WIMR GAS STORAGE AND DISTRIBUTION UNIVERSITY OF WISCONSIN - MADISON MADISON, WISCONSIN

ADDENDUM #1

MSN Project No. **1485-2224** UWSA Project No. **A-22-018**

August 5, 2025

1 ELECTRICAL POWER AND COMMUNICATIONS FIRST FLOOR PLAN
SCALE: 1/8" = 1'-0"

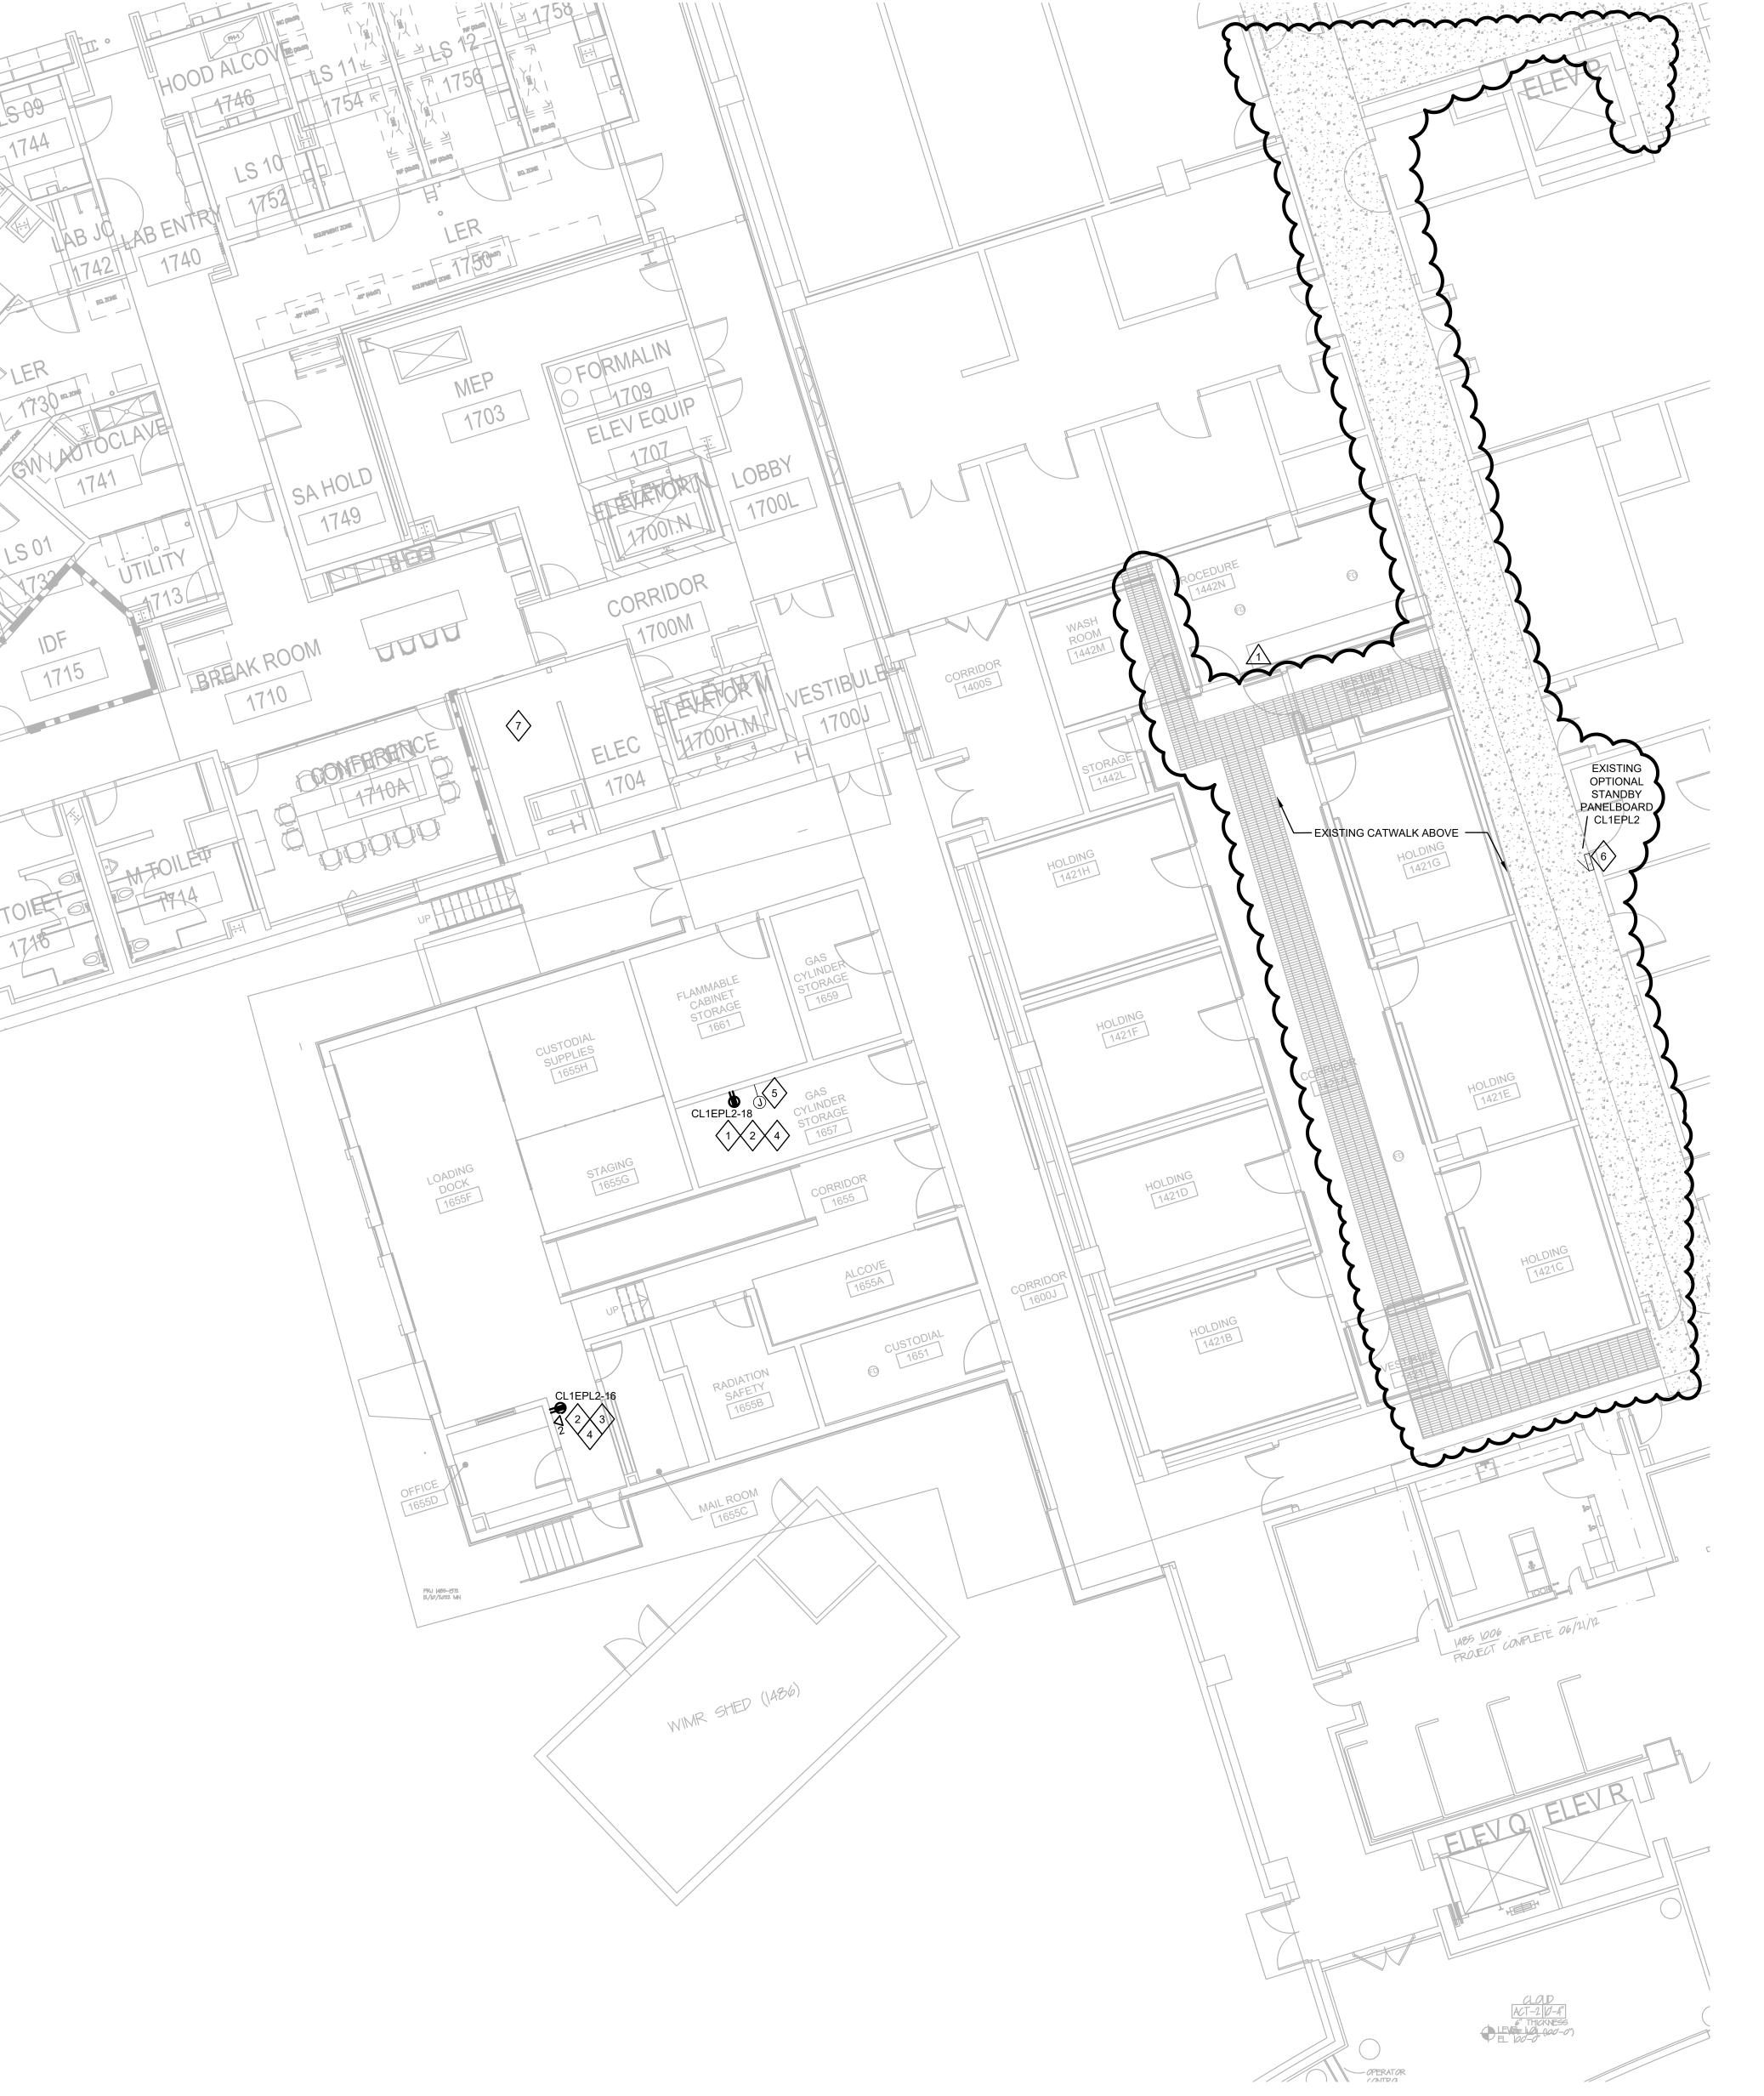
25 26 27 28 29 30 31 32 33 34 35 36	Through the biddin responses to these are in bold . 1. I was at be an ad a.	SUBMITTED BIDDER REQUESTS FOR INFORMATION ag process the following requests for information have been submitted by various interested parties. To ensure a requests are shared with all potential bidders, they are being formally issued as this addendum. Responses the walk through for the WIMR project a couple weeks ago, and it was stated that there was probably going to dendum coming out on how to get to panel in the catwalk. Reference updated Drawing E2.01 issued as part of Addendum No. 1. Beed a bid bond for this project? See bidding requirements for specific information regarding bidding.											
37	CHANGES TO DR												
38 39 40 41 42 43	1. Sheet E a. b.	2.01 – Electrical Power and Communications First Floor Plan Revised sheet keynote 2 to clarify spare circuits are existing in room 1657. Added catwalk located above level 1 for reference. END OF ADDENDUM

1. COORDINATE LOCATION AND MOUNTING HEIGHT OF RECEPTACLE WITH INSTALLATION OF CARBOGEN AUTOMATIC CHANGEOVER MANIFOLD PRIOR TO ROUGH-IN. OPTIONAL STANDBY POWER CIRCUIT

FOR NEW RECEPTACLE SHALL BE FED FROM EXISTING SPARE BREAKER IN OPTIONAL STANDBY POWER PANEL CL1EPL2. SPARE CIRCUIT IS ALREADY PULLED TO ROOM 1657. REFER TO SHEET KEYNOTE 5 FOR ADDITIONAL INFORMATION. 3. COORDINATE LOCATION AND

- MOUNTING HEIGHT OF RECEPTACLE AND COMMUNICATIONS OUTLET FOR EZ GAZ WIFI CONCENTRATOR WITH INSTALLING CONTRACTOR PRIOR TO ROUGH-IN.
- SURFACE MOUNT DEVICES ON EXISTING CONCRETE BLOCK WALL.
- 5. EXISTING JUNCTION BOX WITH SPARE CIRCUITS 16 AND 18 FROM PANEL CL1EPL2. EXTEND EXISTING CIRCUITS TO NEW DEVICES SHOWN IN KEYNOTES 1 AND 2.
- EXISTING PANELBOARD LOCATED IN CATWALK ABOVE.
- 7. FOLLOW EXISTING CABLE PATHWAYS TO ROUTE NEW COMMUNICATIONS CABLES TO TELECOM ROOM 2704 ON FLOOR ABOVE IN THIS APPROXIMATE LOCATION.
